Central Valley Regional Water Quality Control Board

NOTICE OF APPLICABILITY

**WATER QUALITY ORDER 2015-0121-DWQ
GENERAL WASTE DISCHARGE REQUIREMENTS FOR COMPOSTING OPERATIONS
OLD DURHAM WOOD, INC.
OLD DURHAM WOOD, INC. COMPOSTING FACILITY
BUTTE COUNTY**

SUBJECT: APPLICABILITY OF COVERAGE UNDER STATE WATER RESOURCES CONTROL BOARD WATER QUALITY ORDER 2015-0121-DWQ, OLD DURHAM WOOD, INC., 1156 OROVILLE CHICO HIGHWAY, DURHAM, BUTTE COUNTY

Attachment A

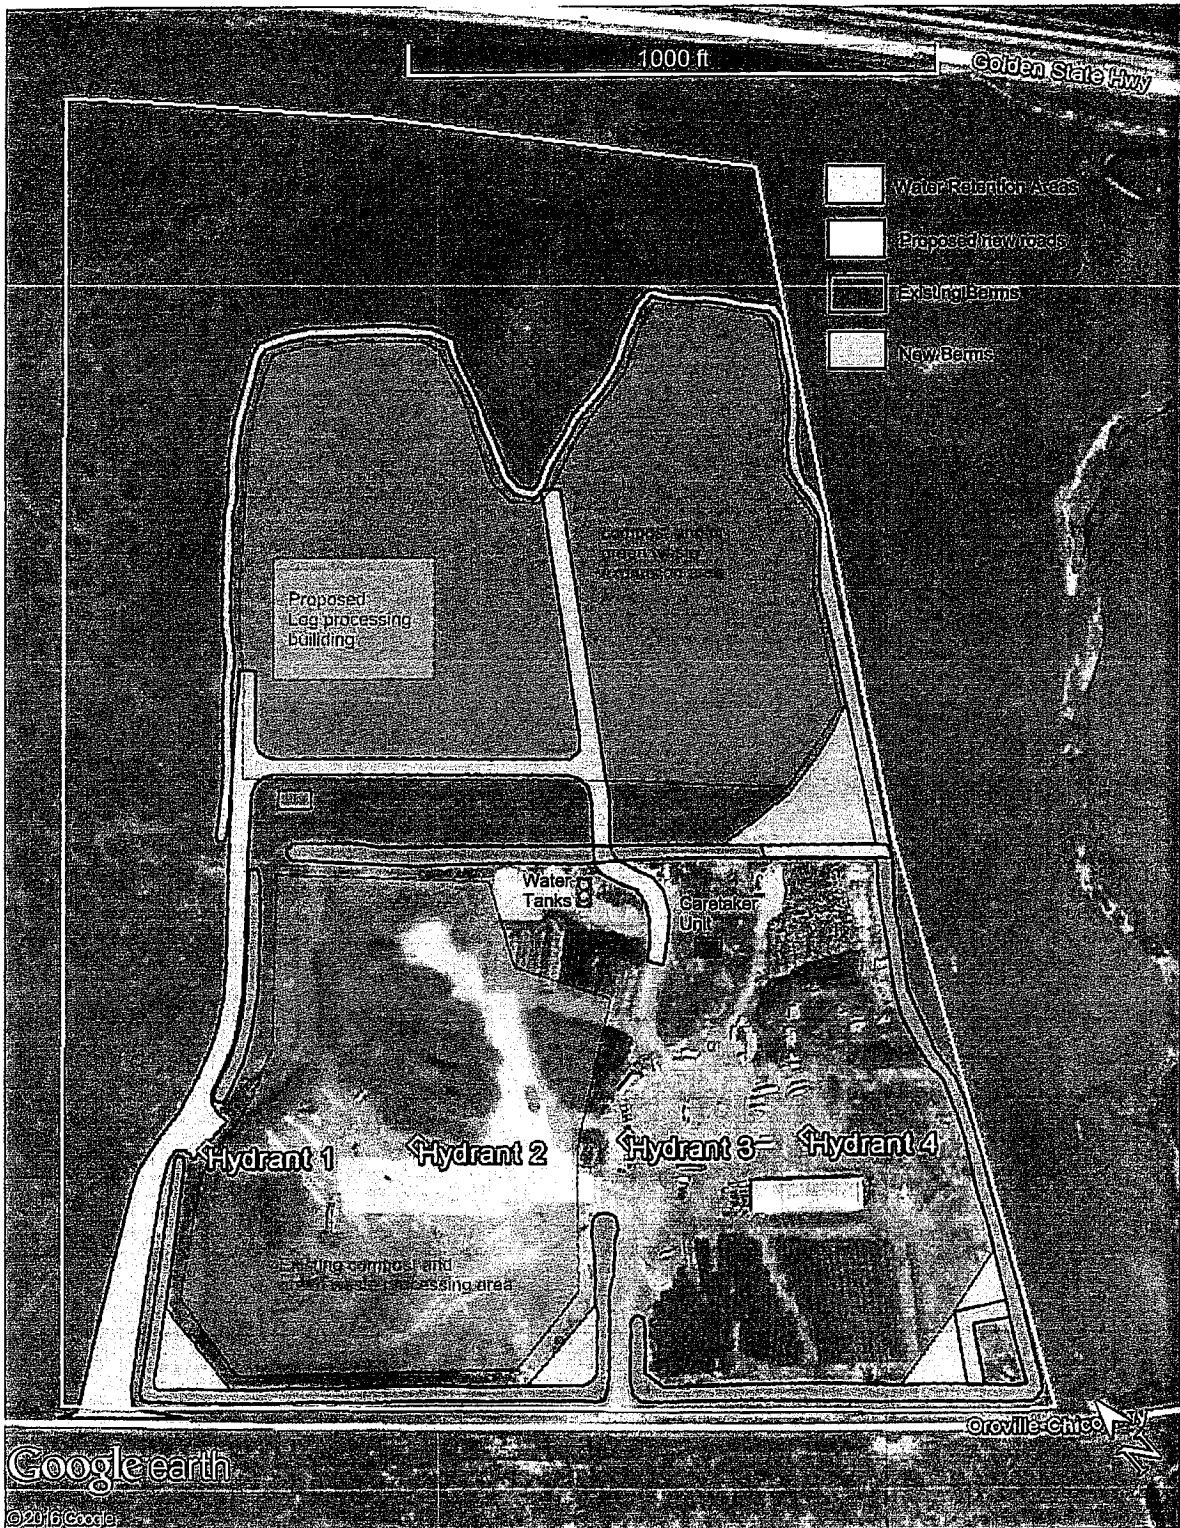
Please note that some storm water features proposed in the Technical Report¹ do not comply with the General Order. Compost operations should not allow discharge of wastes to surface waters, except as regulated under a National Pollutant Discharge Elimination System permit. Discharge of wastes including overflow, wastewater, or bypass from transport, treatment, storage, or disposal systems to adjacent drainages or adjacent properties is prohibited under the General Order. These practices could result in enforcement action by the Central Valley Water.

¹ Proposed outlet pipe that would drain via the roadside ditch to Hanlon Slough and the proposed drain in the southern corner of the property which would drain to the roadside ditch.

Four detention ponds/areas are proposed for controlling runoff and runoff from the working surface. Water during rainfall will drain into one of four onsite detention ponds. Water remaining in the detention ponds after a storm will be siphoned up using onsite water trucks and/or trailers. This water will be reused in the composting process as needed. The Discharger also proposes discharging storm water runoff and wastewater into the roadside ditch which would drain to Hanlon Slough. **This is prohibited under the General Order and these practices could result in enforcement action by the Central Valley Water Board.**
